PRODUCT UPDATE NOTICE

BF200AK3 • BF225AK3 • BF250A Outboards

LEFT TIMING BELT DRIVEN PULLEY REPLACEMENT

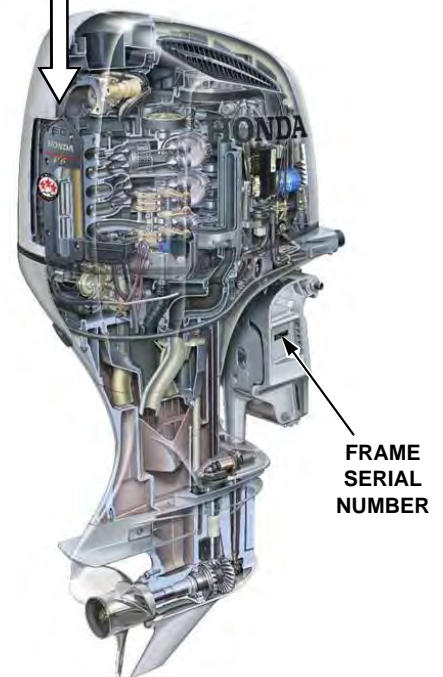
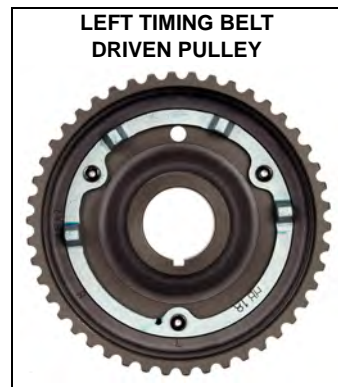
The left timing belt driven pulley may interfere with and damage the TDC sensor due to improper riveting on the pulley’s sensor pick-up plate.

If the left timing belt driven pulley fails, the warning system buzzer on the outboard motor will sound and the engine will shut off and cannot be restarted.

Please contact your Honda Marine servicing dealer to make arrangements to have your BF200AK3, BF225AK3, or BF250A repaired. The dealer will replace the timing belt pulley and, if needed, the TDC sensor at no charge to you while the outboard is still under warranty. Transportation of the outboard to the dealer is the responsibility of the owner.
